Product Change Notice

EPS-AT270 Series Change

- **Notification #:** 2012040001
- **Date of Publication:** 1th of April, 2012
- **Affected Model:** Listed Below
- **Change Description**

Comparison 1 (EPS-AT270-A1-1R)

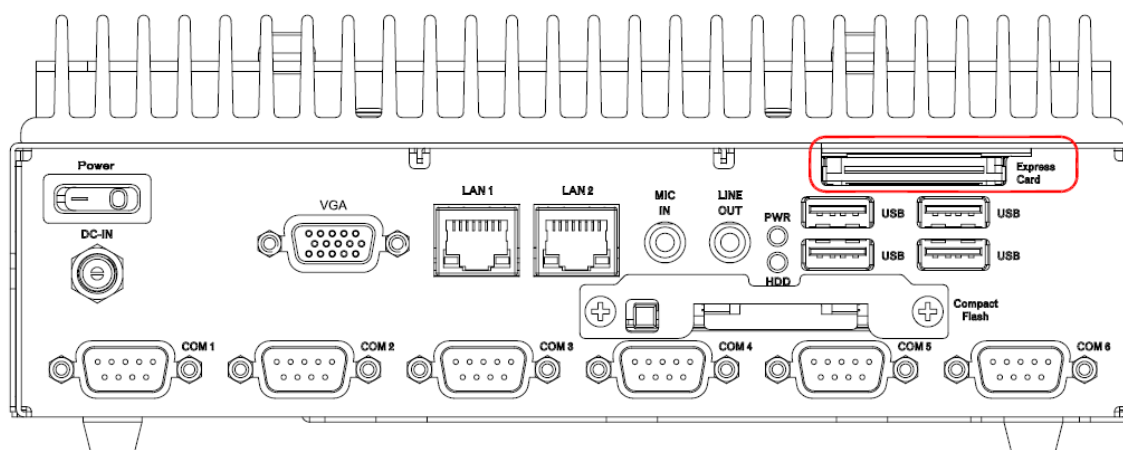
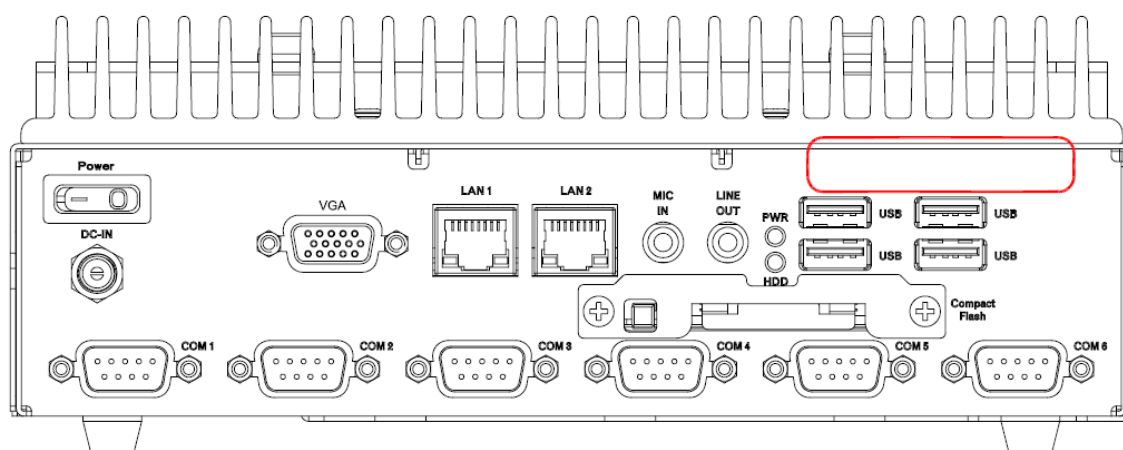
Before – Express Card/34mm Slot on the rear panel

After – Express Card/34mm Slot removed from the rear panel

Comparison 2 (EPS-AT270-A1-2R)

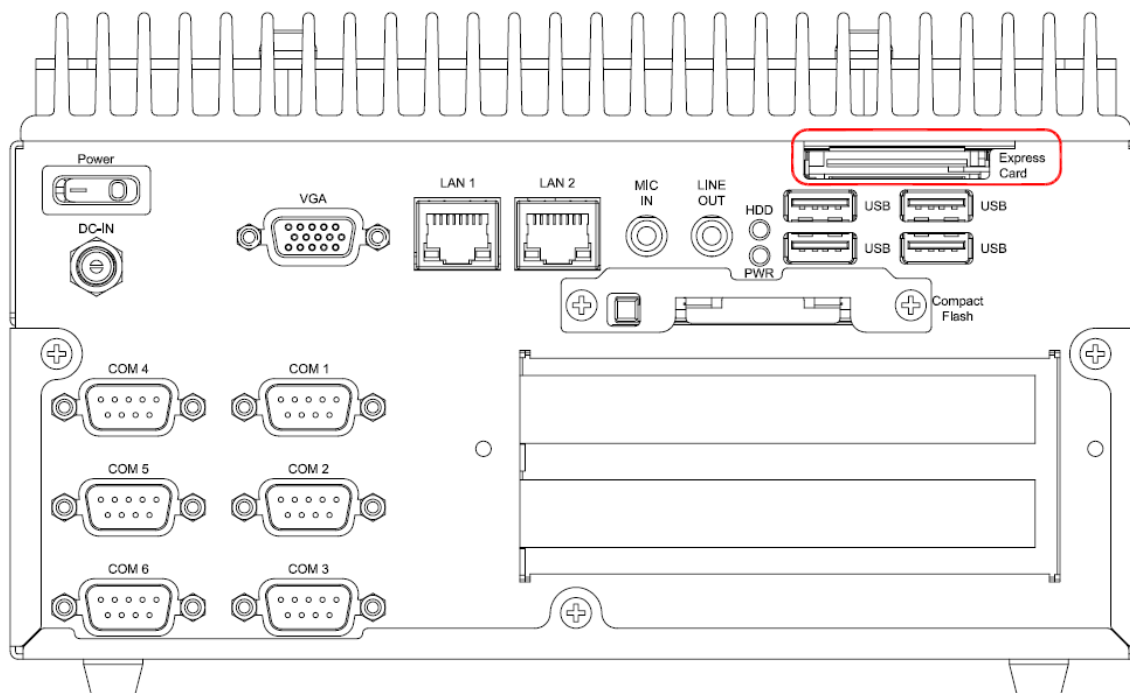
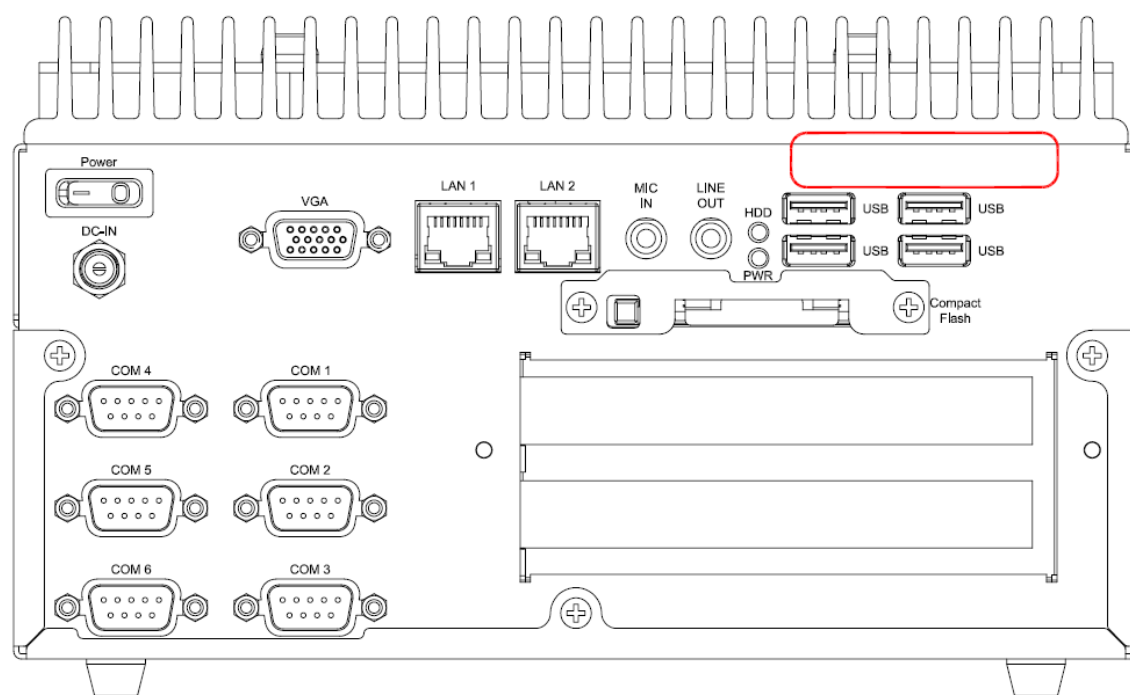
Before – Express Card/34mm Slot on the rear panel

After – Express Card/34mm Slot removed from the rear panel
